10 October 2017

Re: Tweed Sand Quarry (DA 152-6-2005) Application to Increase Extraction Limit – Environmental Assessment – Response to Submissions

Proposed Modification to Hanson's Tweed Sand Quarry (DA156-6-2005) Altona Road, Cudgen

RE: TWEED SAND QUARRY LOT 22, (DP1082435), LOT 23 (DP1077509) AND LOT 494 (DP720450) CRESCENT STREET CUDGEN RESPONSE TO RMS COMMENTS

Figure 2.3: 2017 Peak Hour Design Traffic Volumes

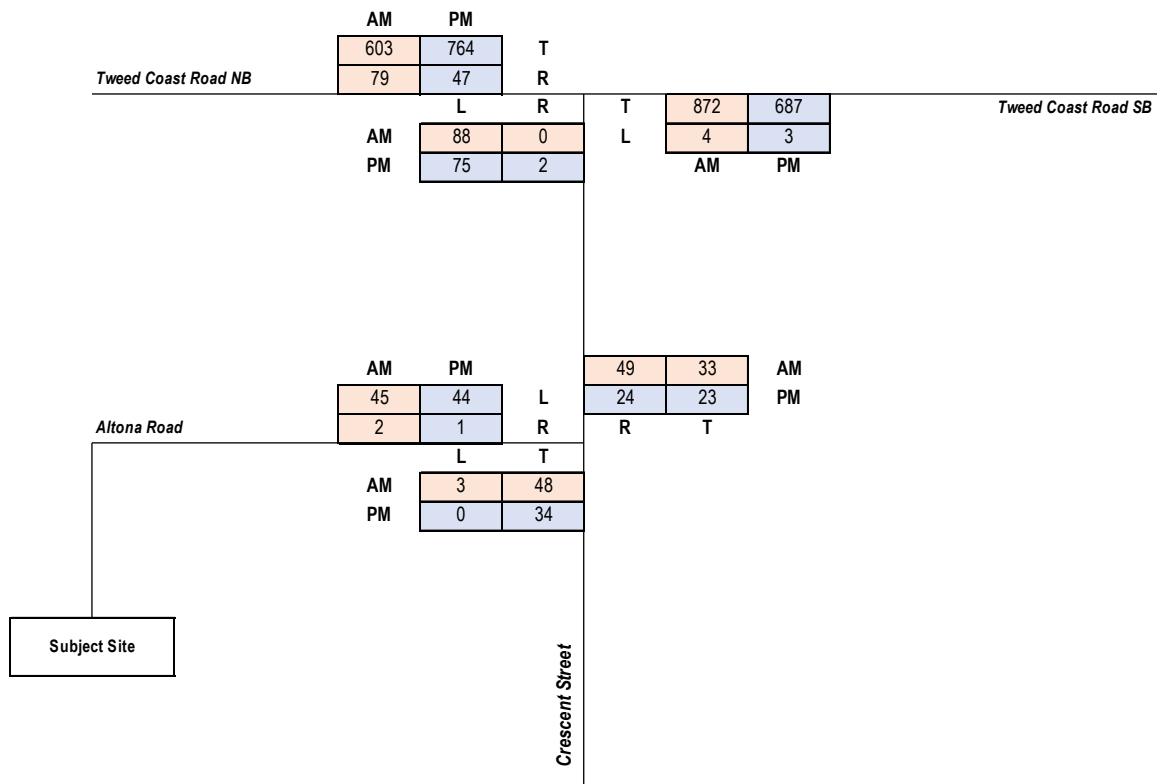
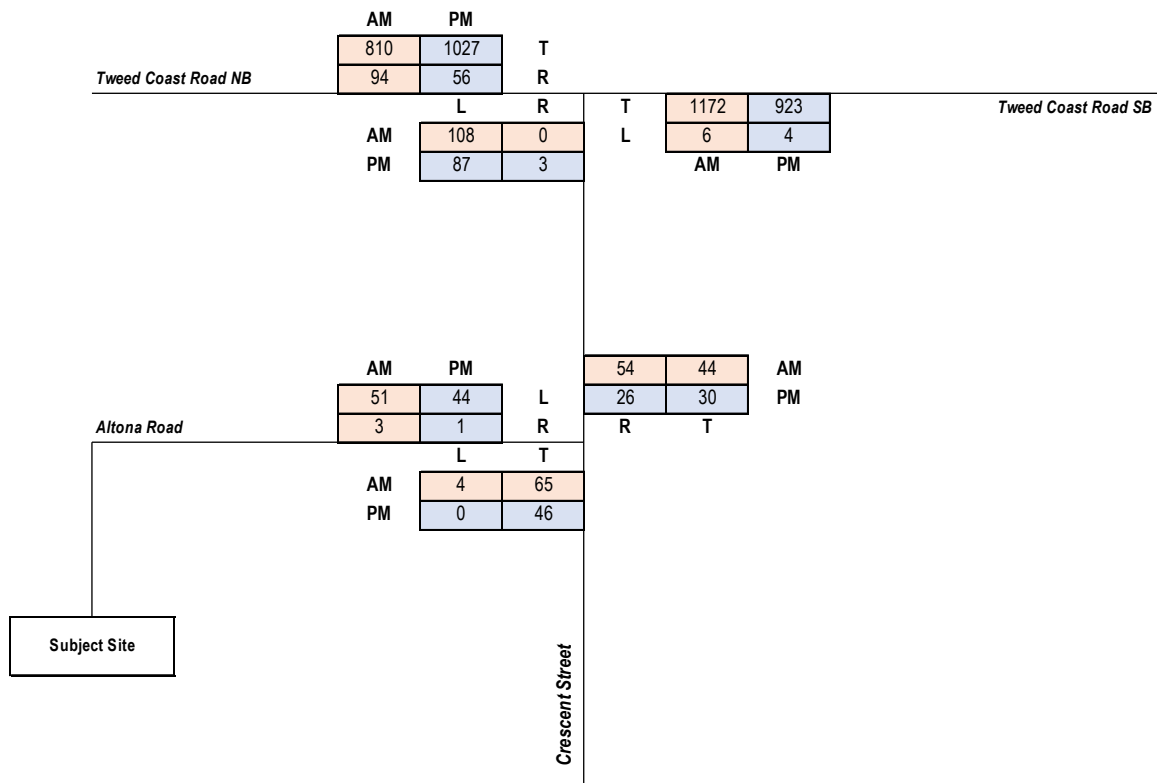
Furthermore, Bitzios concluded the following in response to point 2:

The RMS response has noted 'Consideration should be given to identifying an equitable arrangement for delivery of any intersection improvements...'. Based on the above findings, this is not considered necessary due to the demonstrated compliance regardless of scenario considered, and in particular, the subject intersections in their current form comply with the acceptable performance limits for a priority-controlled intersection with the inclusion of the proposed TSQ development traffic movements.

Figure 2.5: Tweed Coast Road / Crescent Street Intersection Layout

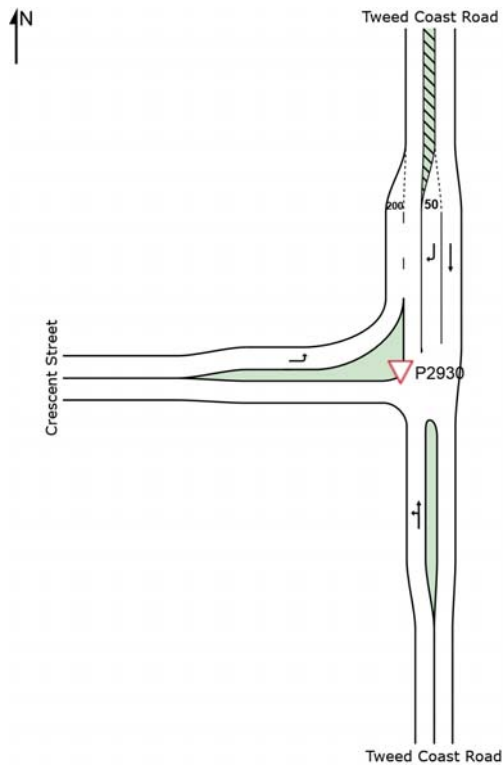
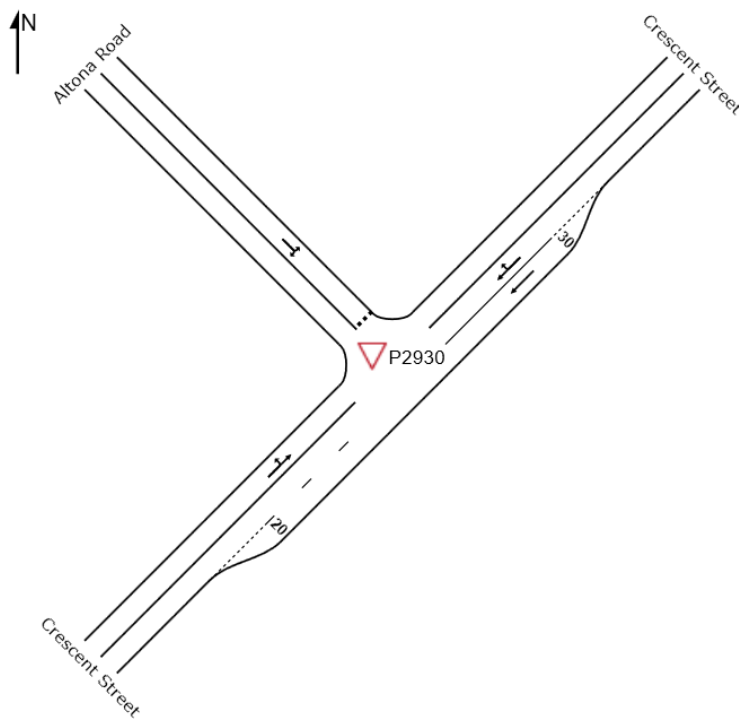
In response to point 3, Bitzios concluded:

[T]he intersections are considered to provide sufficient sight distance to comply with the requirements prescribed by Austroads for heavy vehicles.

As demonstrated in Table 2.4, the intersections are considered to provide sufficient sight distance to comply with the requirements prescribed by Austroads for heavy vehicles.

Attachment 3 – HCM Driver Code of Conduct, and TSQ primary haul route

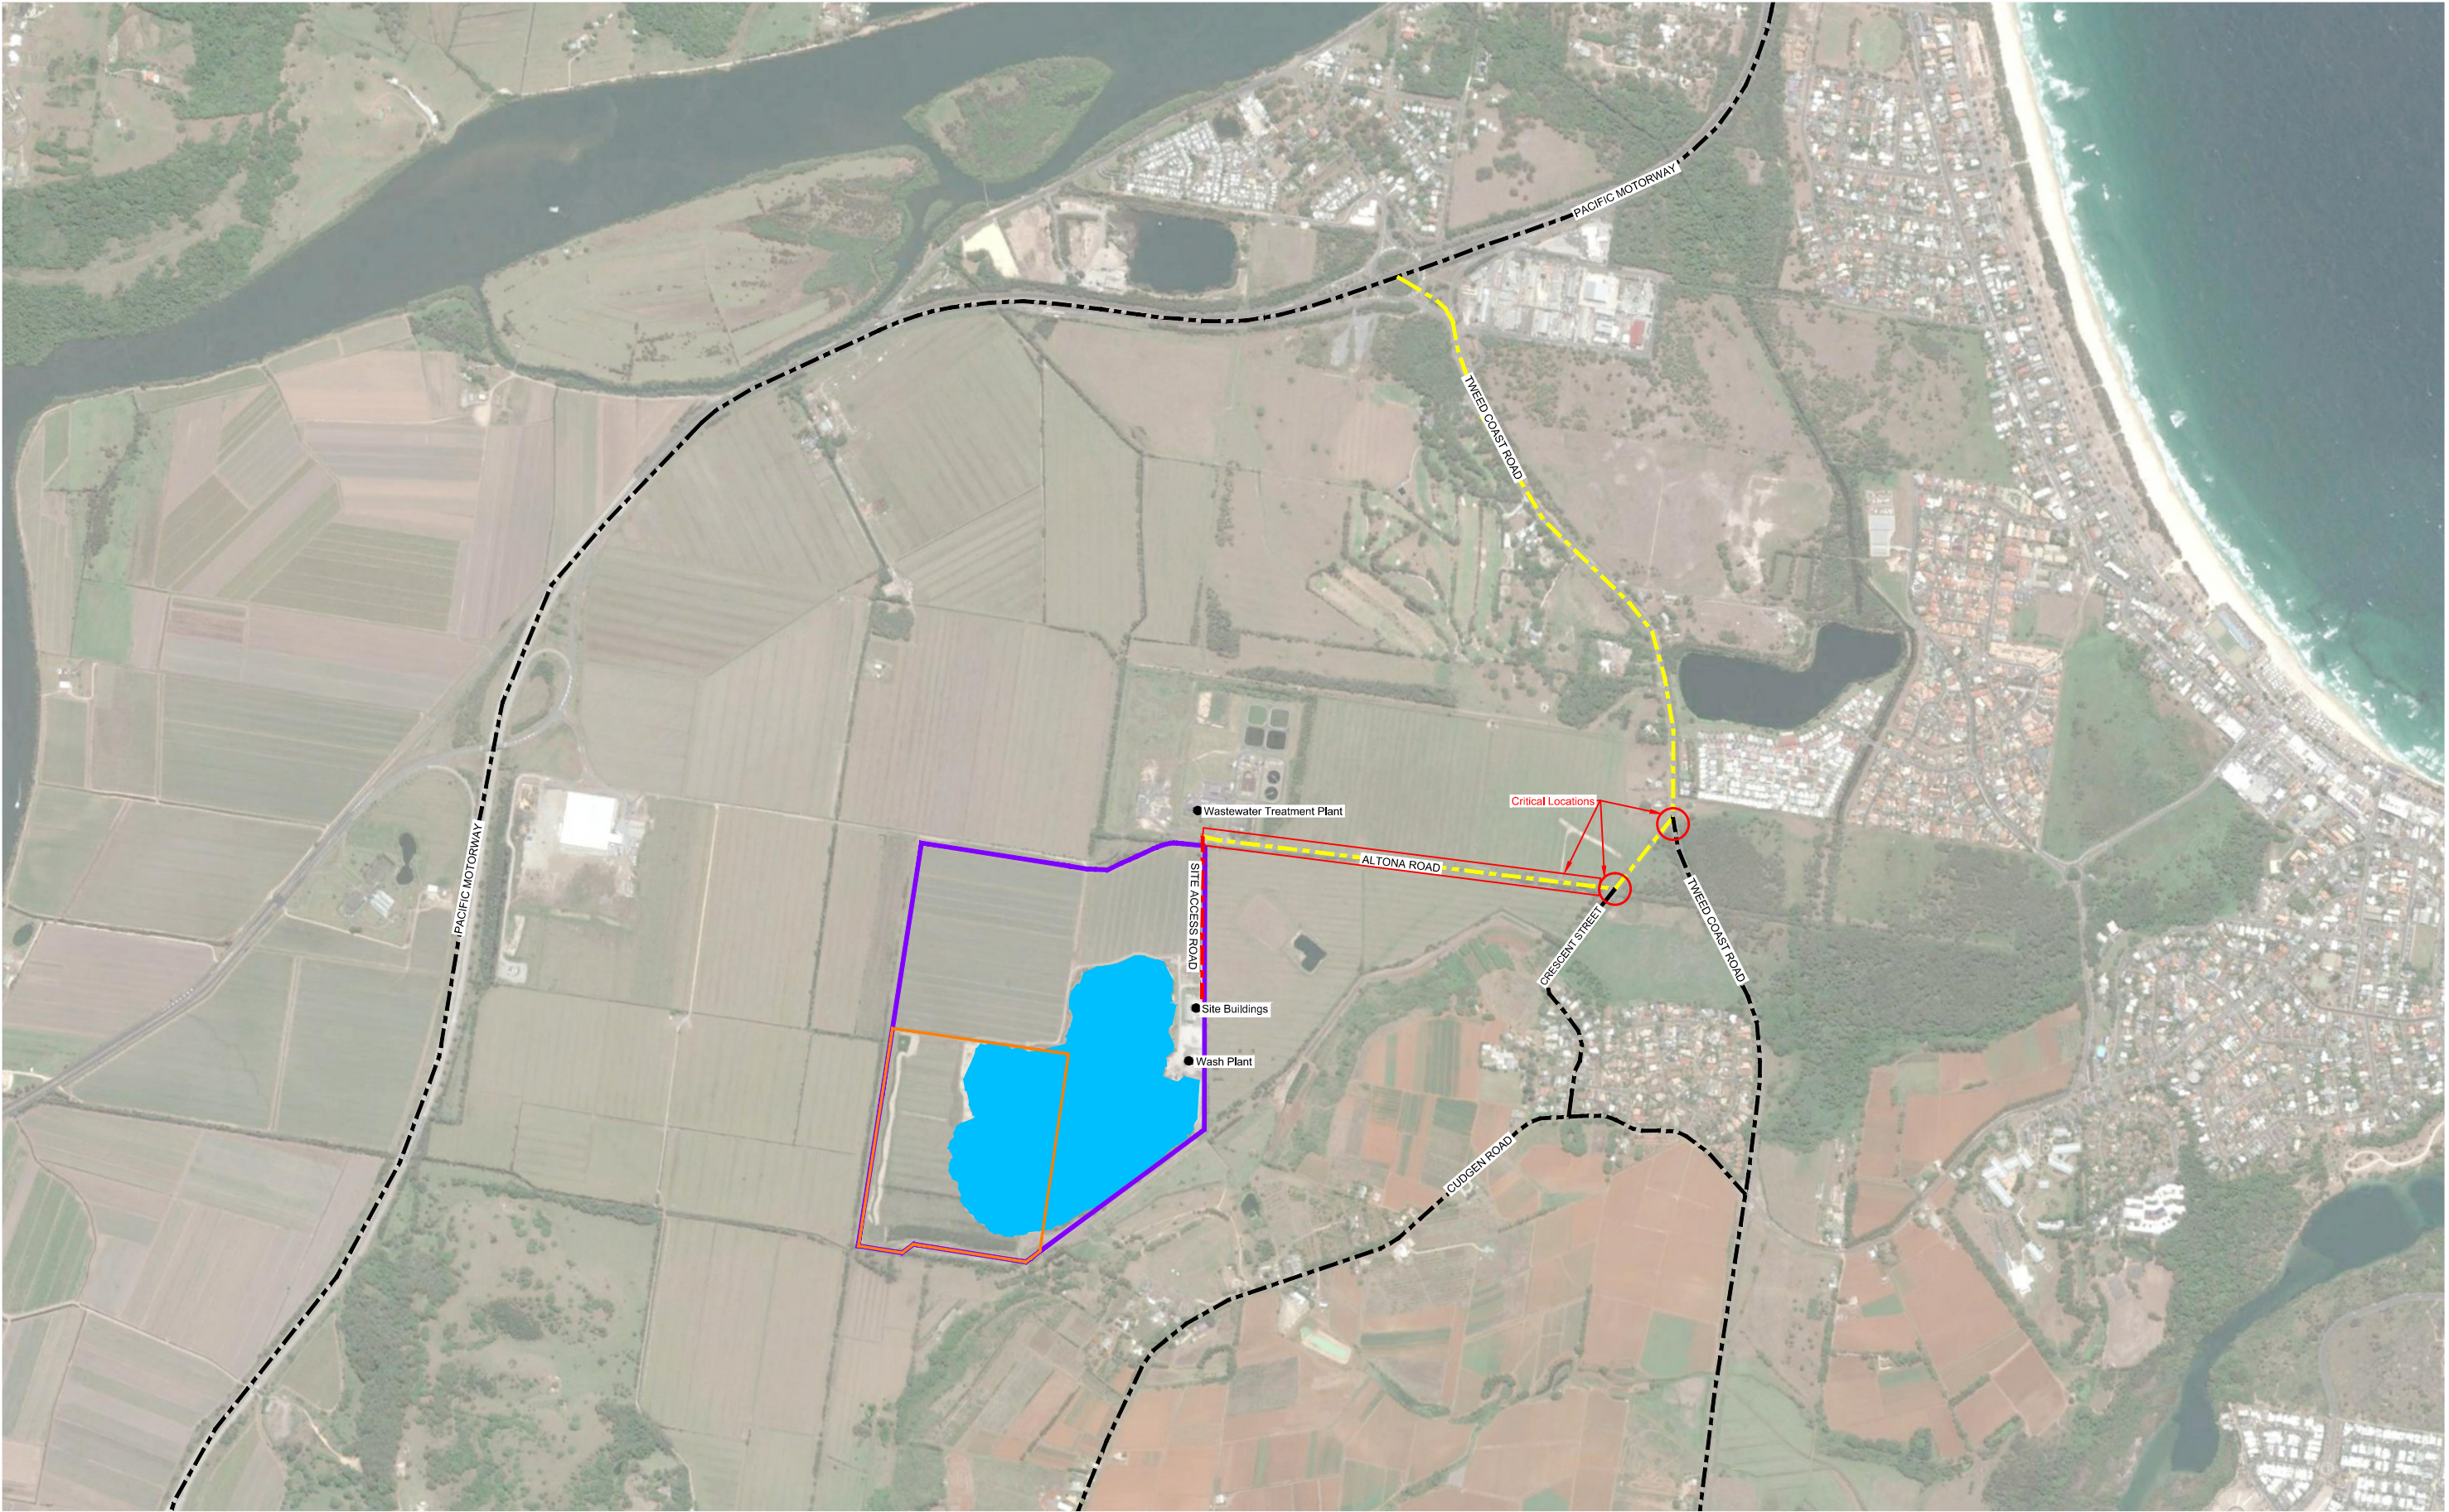
As shown on the primary haulage route map (Drawing '11792_DA_P4_003'), this route passes adjacent to residential areas (West Kingscliff), however does not pass directly through residential areas or school zones. The route that passes adjacent to West Kingscliff is on Tweed Coast Road (sign posted speed of 80 km/hr), and is separated by a noise barrier. The remaining haul route is along rural residential and industrial areas. No further safety initiatives outside those stated in the June 2017 EA submission are considered necessary.

In response to RMS' point 4, HCM currently has a Driver Code of Conduct for TSQ. A copy of this Driver Code of Conduct is contained in Attachment 3. This is supplemented by a map showing the primary haulage route (Altona Road, Crescent Street, Tweed Coast Road, and Pacific Highway – see Drawing '11792_DA_P4_003' in Attachment 3), and identifies critical locations relevant to this primary haul route.
